Process Sheet

| Customer : CU-DAR001 Dart Helicopters Services | Drawing Name : ARM |
| This Issue : 22/10/2007 S.O. No. : | Drawing Number : D3560 UNDER REVIEW <i>9/12</i> |

From: David Shepherd [mailto:dshepherd@dartaero.com]
Sent: September 10, 2008 1:36 PM
To: 'Alan Stocker'
Cc: 'Chris Provencal'; 'Mike Petsche'; 'Bill Beckett'; 'Susanne Sheldon'
Subject: RE: D3560-044 & -042 Cracking

D3560-043 ARM WELDMENT (SHOWN),
D3560-044 ARM WELDMENT (OPPOSITE)

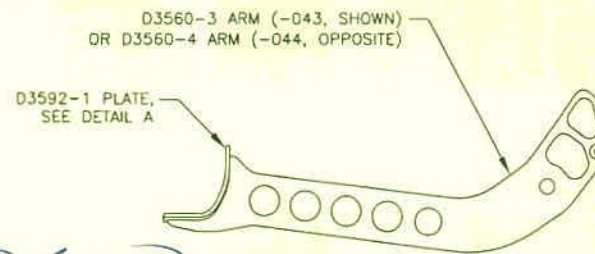
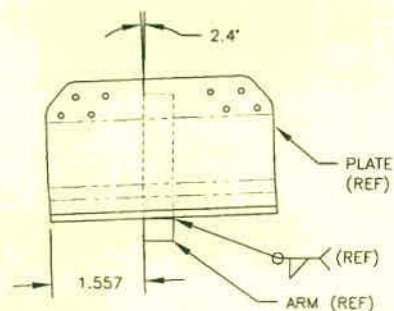
| NCR: <u>35218</u> | | WORK ORDER NON-CONFORMANCE (NCR) | | | | | | |
|-------------------|----------|---|---|--|-----------------------------|--|---|---|
| 8/9/15 | # FID | During welding inspection it was found that 5 parts have cracks from the D3560-1 plate from welding R.C. Grain runs along the weld. |  08/09/15 | Scrap and Destroy 21 5 AS PER Email From David Shephard to Alan Stacker on 8/9/10 @ 1:36pm See CAR 08-026 | 09/08/17 SAD 08/09/11 |  08/01/17 |  08/09/15 |  08/01/15 |

We have 13x D3560-044 and 1x D3560-042 that have cracks all but 1 in the same location.
Attached image D3560-044 Crack 1 shows where 13 of the 14 cracks occurred. D3560-044 Crack 2 shows where the other crack occurred. The cracks shown in D3560-044 Crack 1 vary in depth from roughly 3/32 to 1/2 inch. I discussed this with Chris and Peter the consensus opinion is the parts are scrap. Further discussion with Chris indicates that changing grain direction to 45 degree on the sheet metal part may lower the scrap rate but not eliminate it. This has been done on a previous deviation with a less scrap. D3560-044 Crack 2 appears to just be an anomaly.

Thanks for the pictures.
I am not comfortable with any sort of repair to these parts.
I think that all 14 parts should be scrapped.
And, at the risk of stating the obvious, we need to revisit the manufacturing process of this joint.
My preference, as it was a couple of years ago, is to eliminate this weld.
However, the geometry in that area is a little tricky.
Suggest we generate an NCR or PAR or whatever.
